Specification for Rotary Drill Stem Elements

ANSI/API SPECIFICATION 7-1
FIRST EDITION, MARCH 2006

EFFECTIVE DATE: SEPTEMBER 2006
ADDENDUM 1: JANUARY 2007

Addendum 1 to Specification for Rotary Drill Stem Elements

Figure 11 — Dimensions of Heavy Weight Drill Pipe

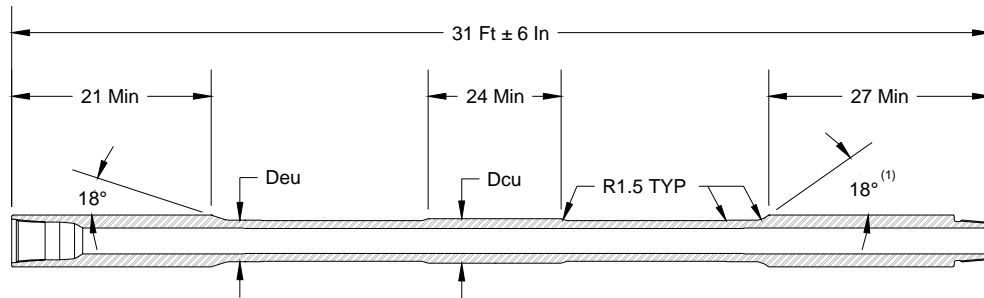
Add the following new clause 10. Renumber the current clause 10 Nondestructive examination of bars and tubes and sub clauses as clause 11.

Heavy weight drill pipe (HWDP) shall be furnished in the sizes and dimensions shown in Table 27 and as illustrated in Figure 11.

- 1 35 degree taper on the pin end at the manufacturers option.
- 2 All dimensions are in inches, except as noted.
- 3 The center upset shall be located approximately mid length of the tube.

Note – The above dimensions apply to both integral and welded Heavy Weight Drill Pipe.
